HISTORIC AND DESIGN REVIEW COMMISSION

February 15, 2017

HDRC CASE NO: 2017-052
ADDRESS: 2142 W MAGNOLIA AVE
LEGAL DESCRIPTION: NCB 6829 BLK LOT 13, W 5 FT OF 12
ZONING: R-6,H
CITY COUNCIL DIST.: 7
DISTRICT: Monticello Park Historic District
APPLICANT: Gloria Torres
OWNER: Gloria Torres
TYPE OF WORK: Demolition of rear addition, construct new addition
REQUEST:

Demo Plan

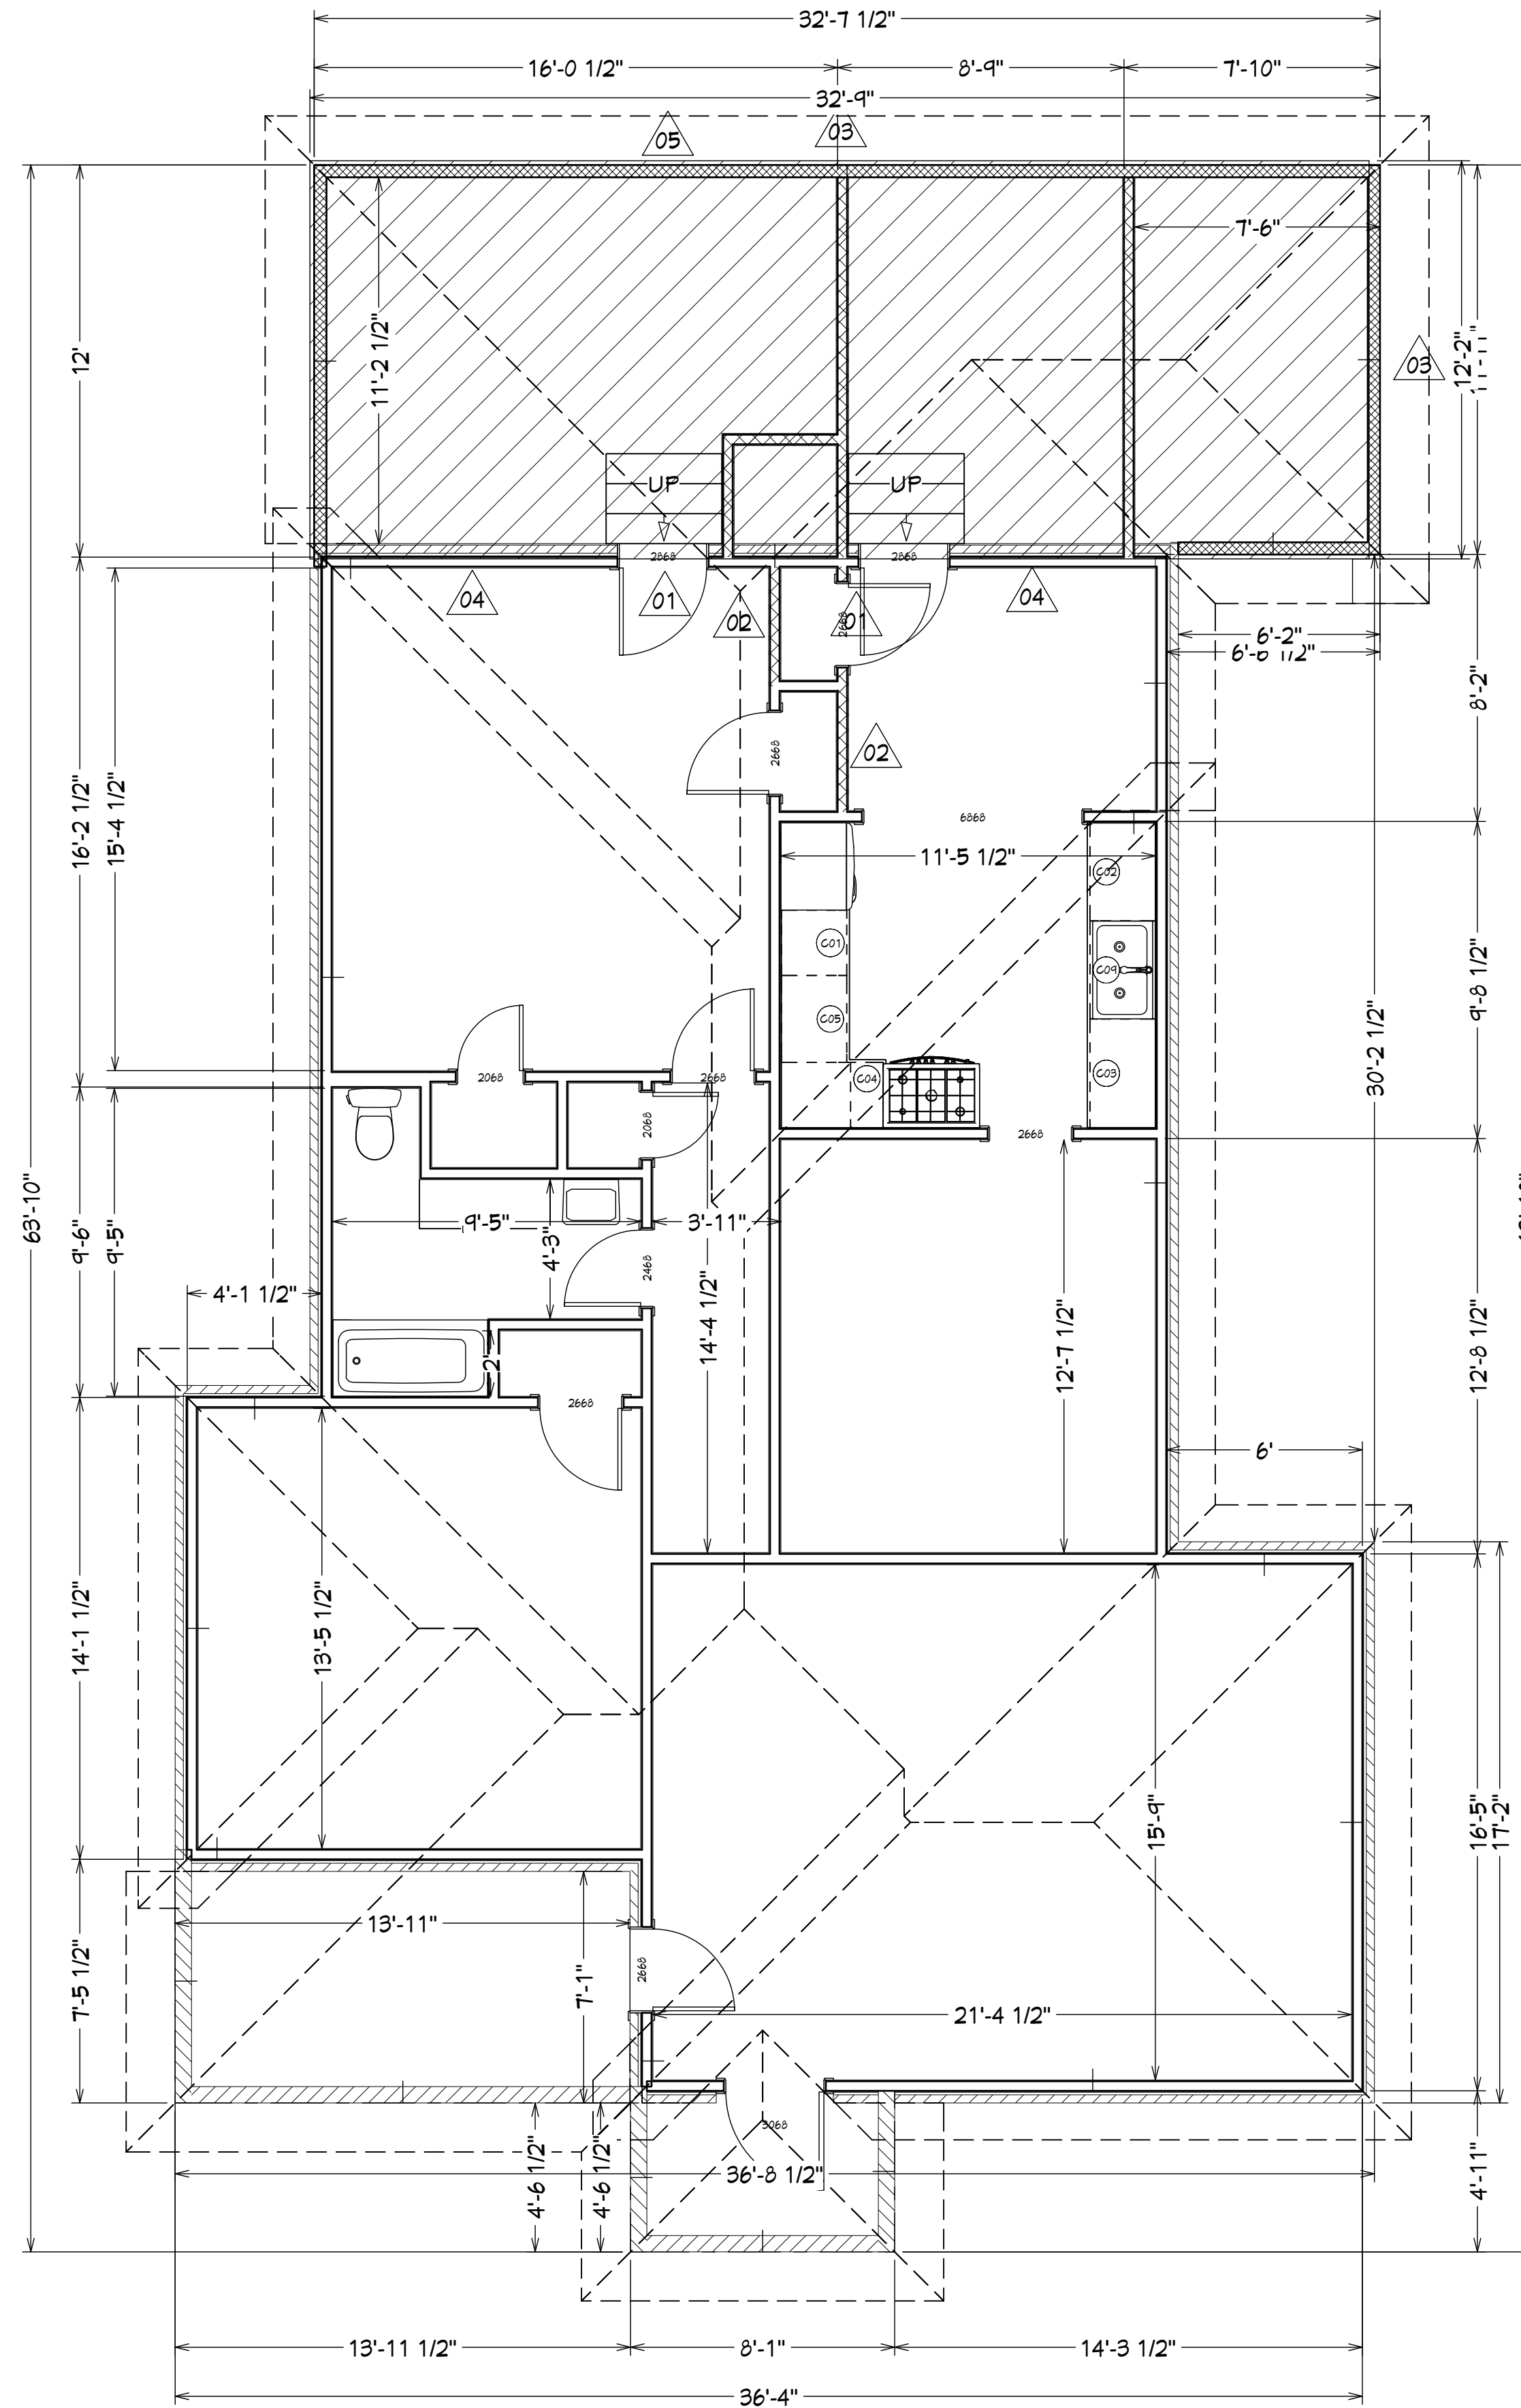
- b. EXISTING ADDITION – There is an existing non-contributing addition with wood lap siding on the rear of the primary structure. The applicant is proposing to remove this existing rear addition and build a new addition on the rear. Staff finds the removal of addition appropriate.

Rear Elevation

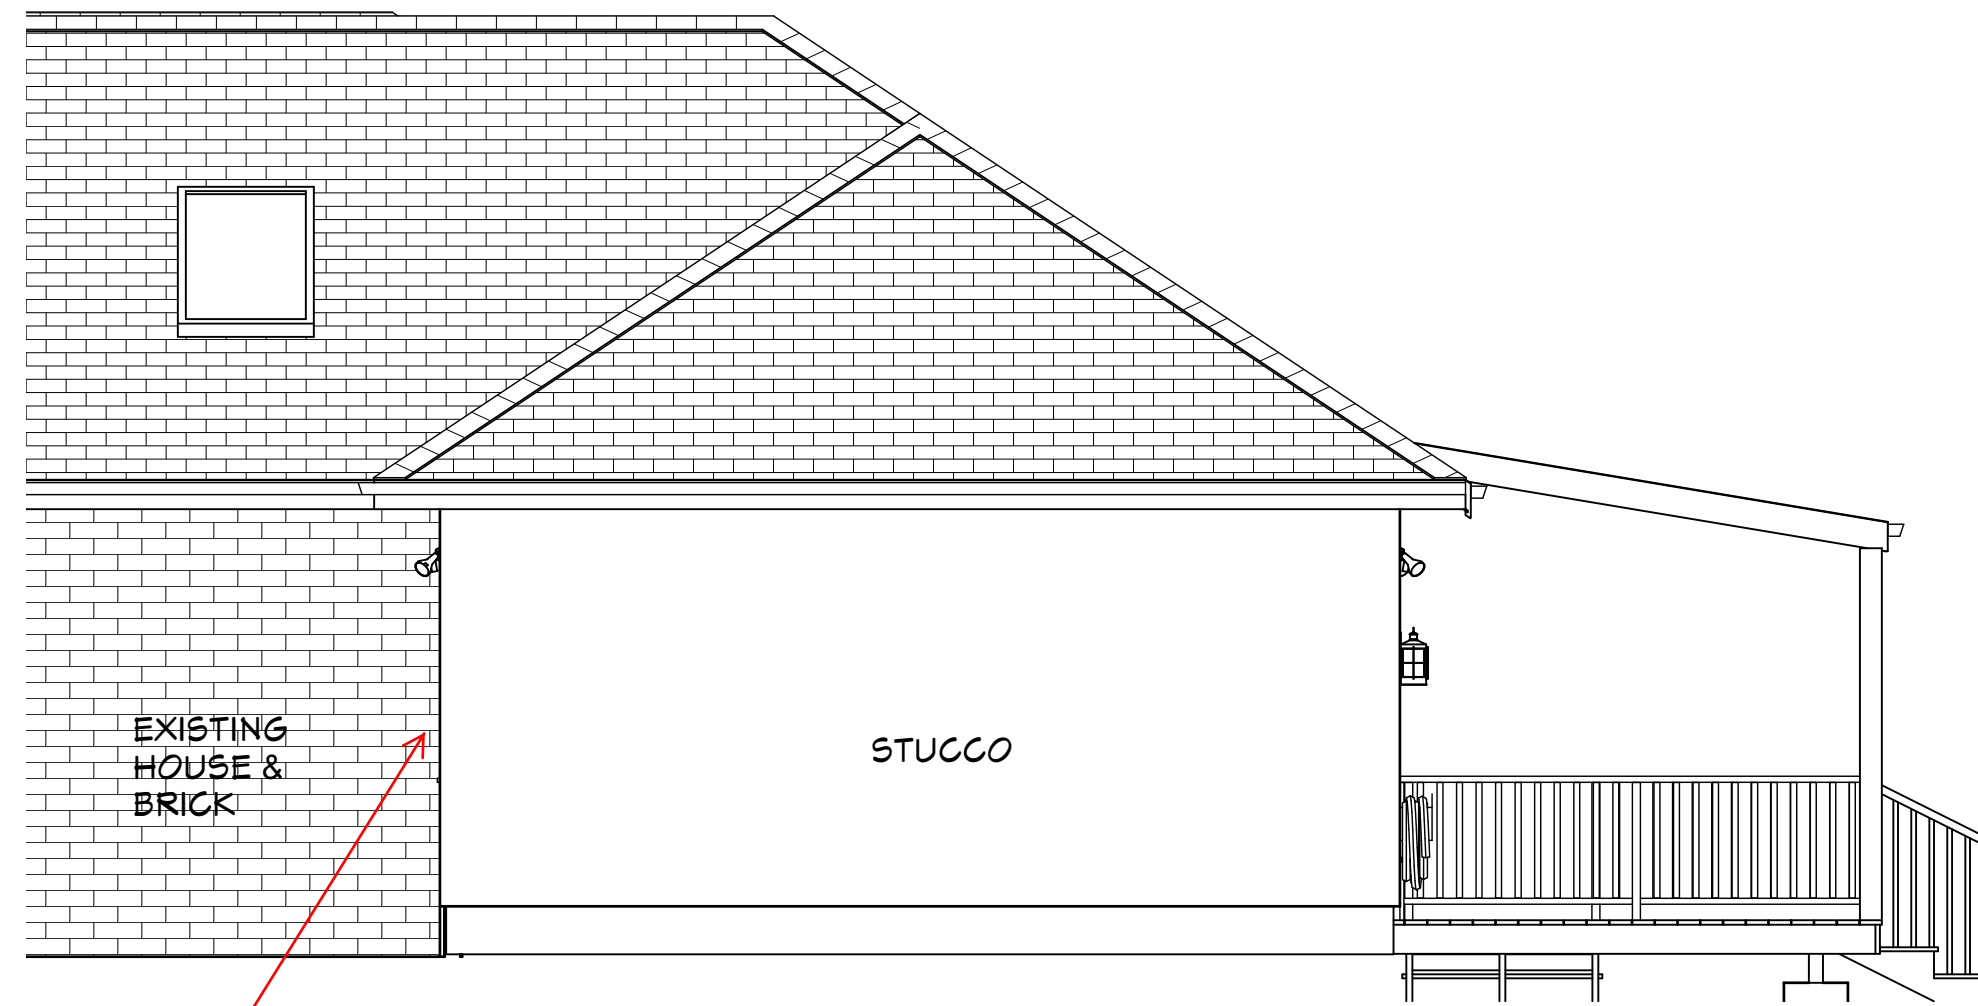
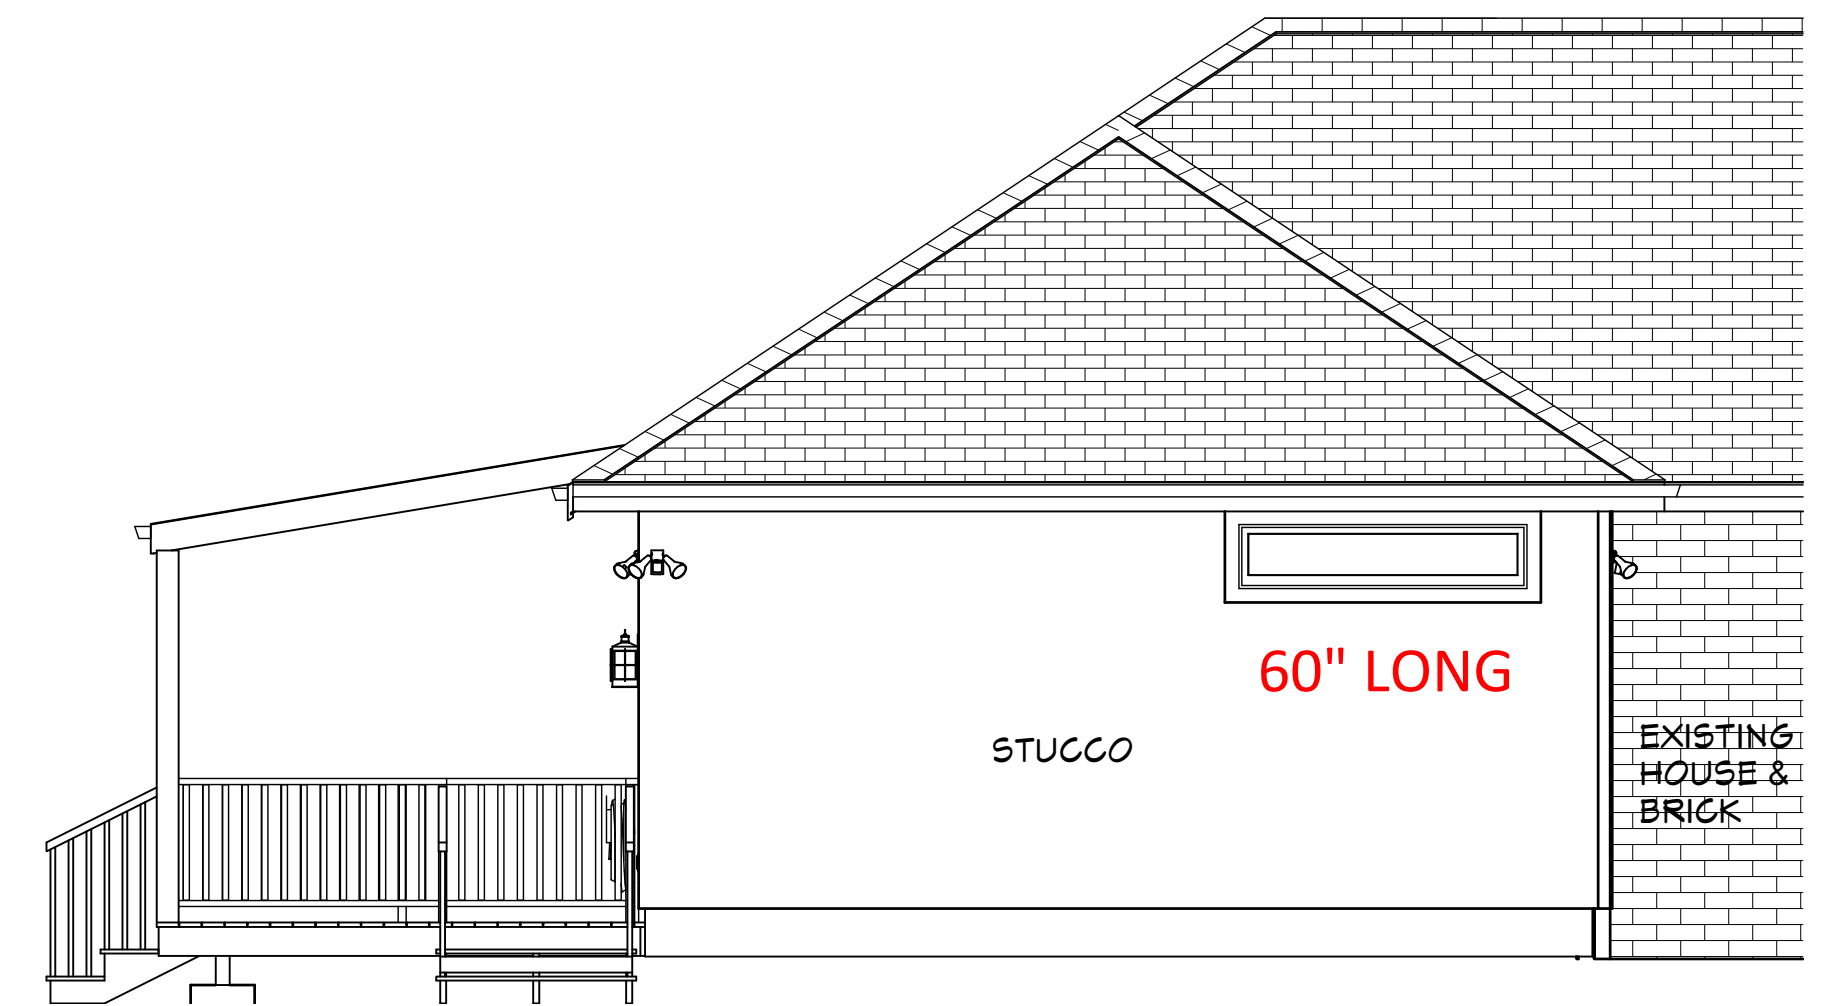
- h. **RELATIONSHIP TO SOLIDS AND VOIDS** – There is proposed fenestration on the right portion of the rear façade with a triple window featuring three vinyl one over one windows. According to the Guidelines for New Construction 2.C.i, windows, doors, and porches shall be considered similar if they are no larger than 25% in size and vary no more than 10% in height to width ratio from adjacent historic facades. Avoid blank walls, particularly on elevations visible from the street. Staff finds the proposed blank right façade, the blank façade to the left of the proposed rear door and the right façade with only one long horizontal window not consistent with the Guidelines. Facades with increased fenestration and openings of similar proportions are appropriate.

- 1. That window fenestration is added to the right façade of the proposed addition.
- 2. That window fenestration is added to the left façade of the proposed addition.
- 3. That window fenestration is added to the left portion of the rear façade of the proposed addition.
- 4. That the horizontal window on the right elevation is deleted and a window that is similar in proportion of the wood one over one windows is installed.
- 5. That new windows are made of wood, feature clear glass, maintain the original appearance of window trim and sill, and be inset at least two inches.
- 6. That details of these stipulations be submitted to staff prior to receiving a Certificate of Appropriateness.
